Vogtle Project

NRC DOCKET NUMBERS 50-424 AND 50-425
CONSTRUCTION PERMIT NUMBERS CPPR-108 AND CPPR-109
VOGTLE ELECTRIC GENERATING PLANT - UNITS 1 AND 2
SER CONFIRMATORY ITEM 44: TMI ITEM I.C.1

CONFIRMATORY ITEM 44

(REQUEST FOR ADDITIONAL INFORMATION)

SG BLOWDOWN & SAMPLE ISOLATION VALVE LOGIC

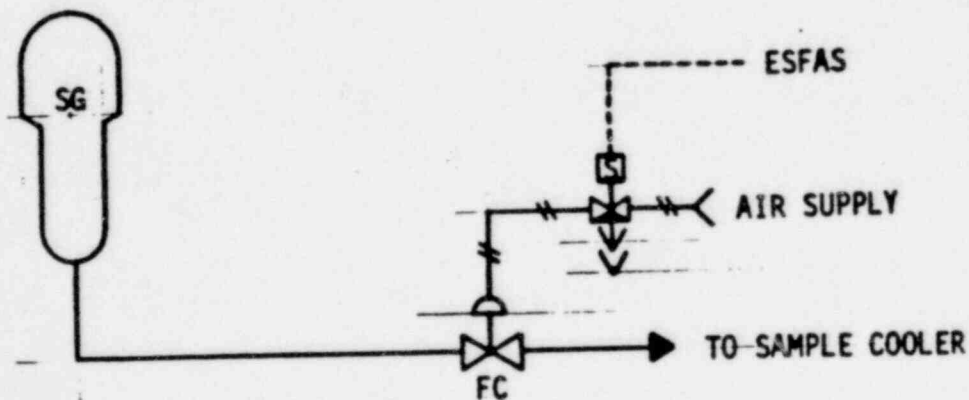
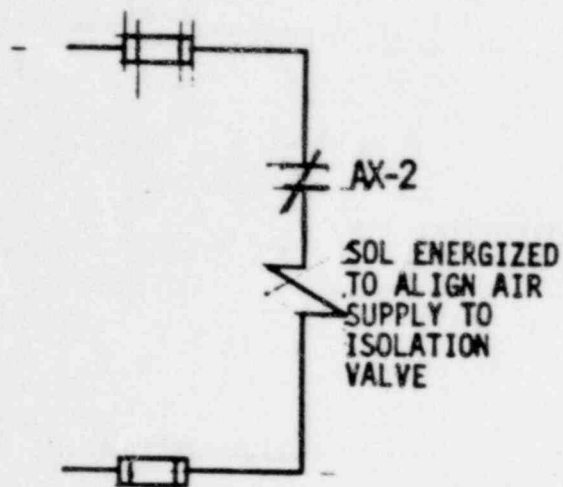
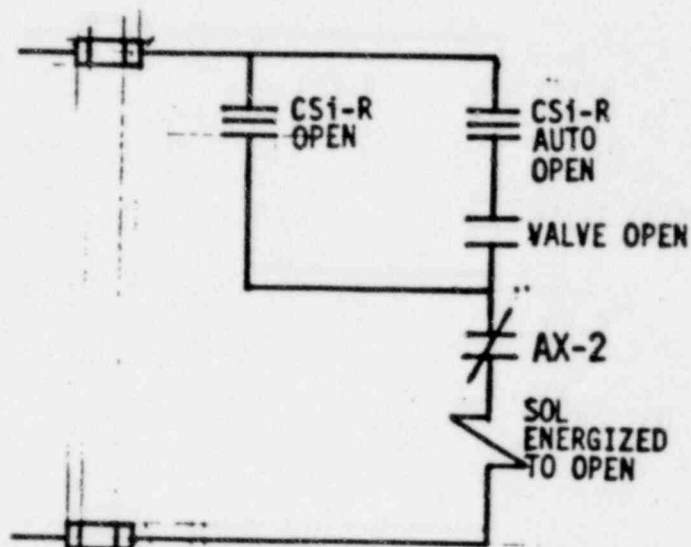
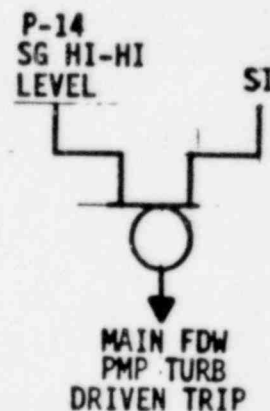
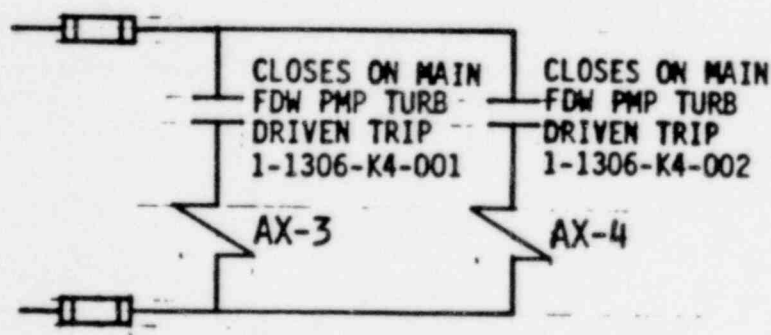
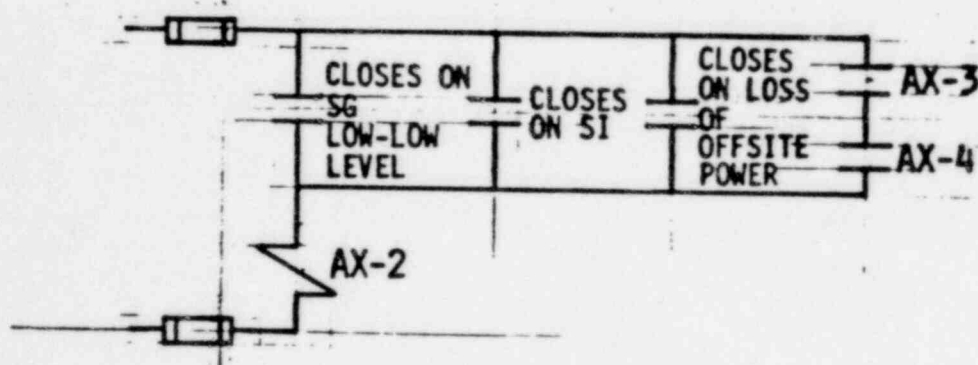
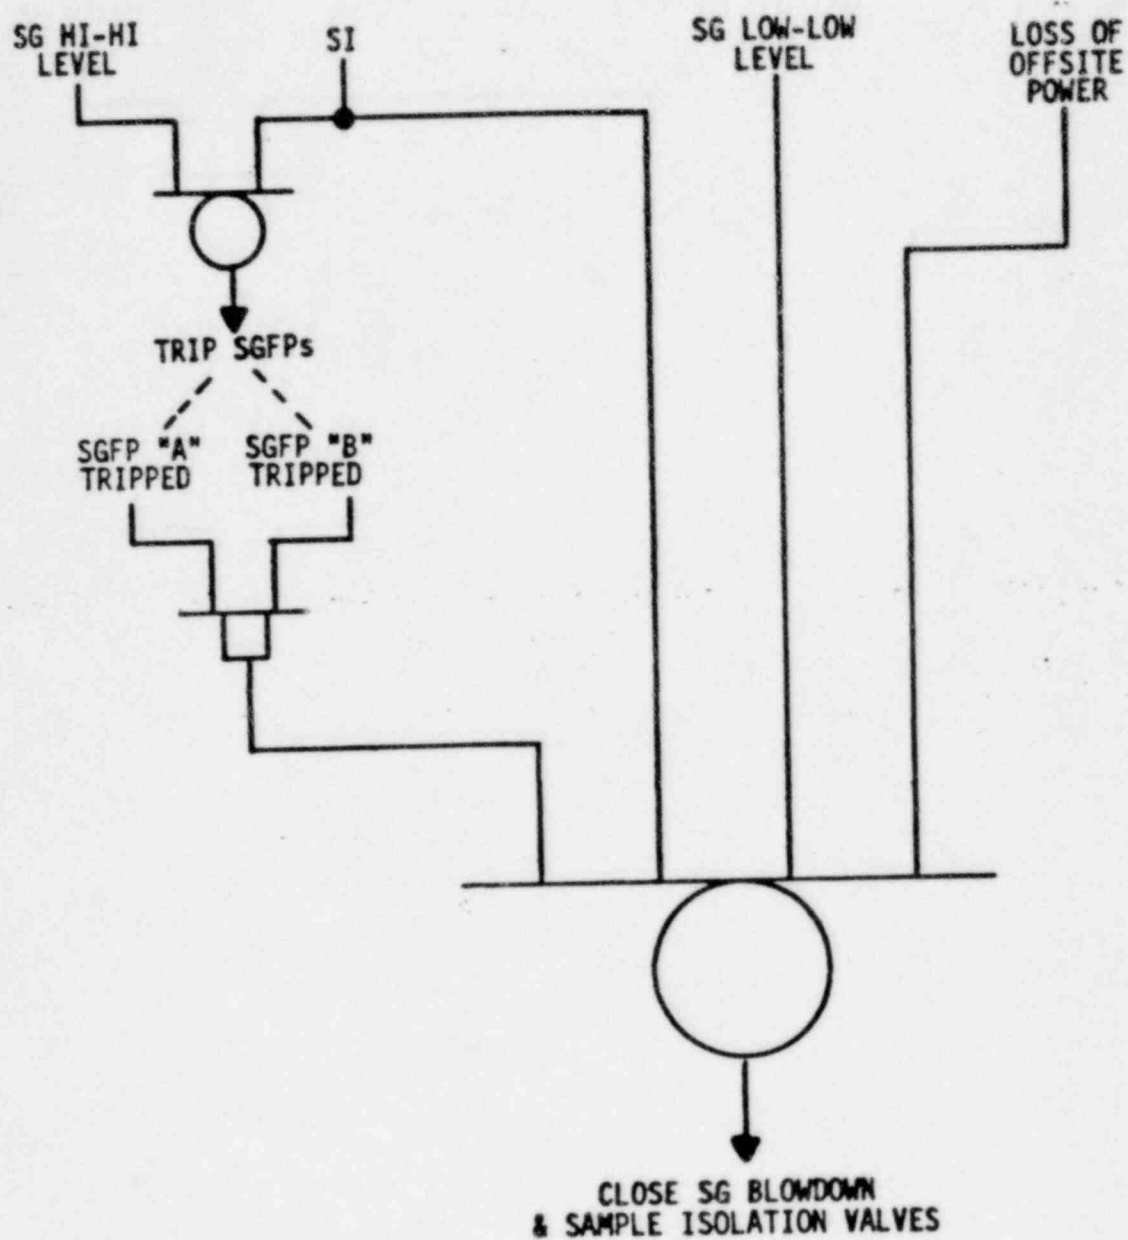
2. Justify the elimination of sample line radiation and blowdown line radiation from the procedure identifying a ruptured steam generator. (EOP #19030-1 (ERG #E-3) Step #2).

In order for the operator to be in Procedure 19030-1 (E-3), the primary to secondary leakage is substantial enough to cause SI actuation. Without SI actuation, the operator is directed to the Abnormal Operating Procedure for SG tube leakage, instead of 19030-1.

Two methods are provided in 19030-1 for determining the ruptured SG. These are: 1) an unexpected rise in the SG level, or 2) high radiation in a main steam line.

In the case of a large tube rupture, SG level provides obvious indication of the ruptured SG. A comparison of the SG level trends from the recorders show the ruptured SG. For smaller tube ruptures, the urgency is not as critical and time is available for monitoring SG level and steam line radiation for changes that indicate a ruptured SG. High main steam line radiation is available regardless of size of tube failure to identify the leaking steam generator. VEGP did not include SG sampling and blowdown radiation as methods for determining the ruptured SG because these process lines are isolated by SI actuation. The attached diagrams show the logic and circuitry which provides the isolation signal for these valves. In addition, there are certain plant conditions which prevent re-opening of the blowdown and sample isolation valves (see attachment B). Even for cases where the valves can be re-opened, the steps involved to check each SG require complicated and time consuming local operator actions which should not be included in procedure 19030-1.
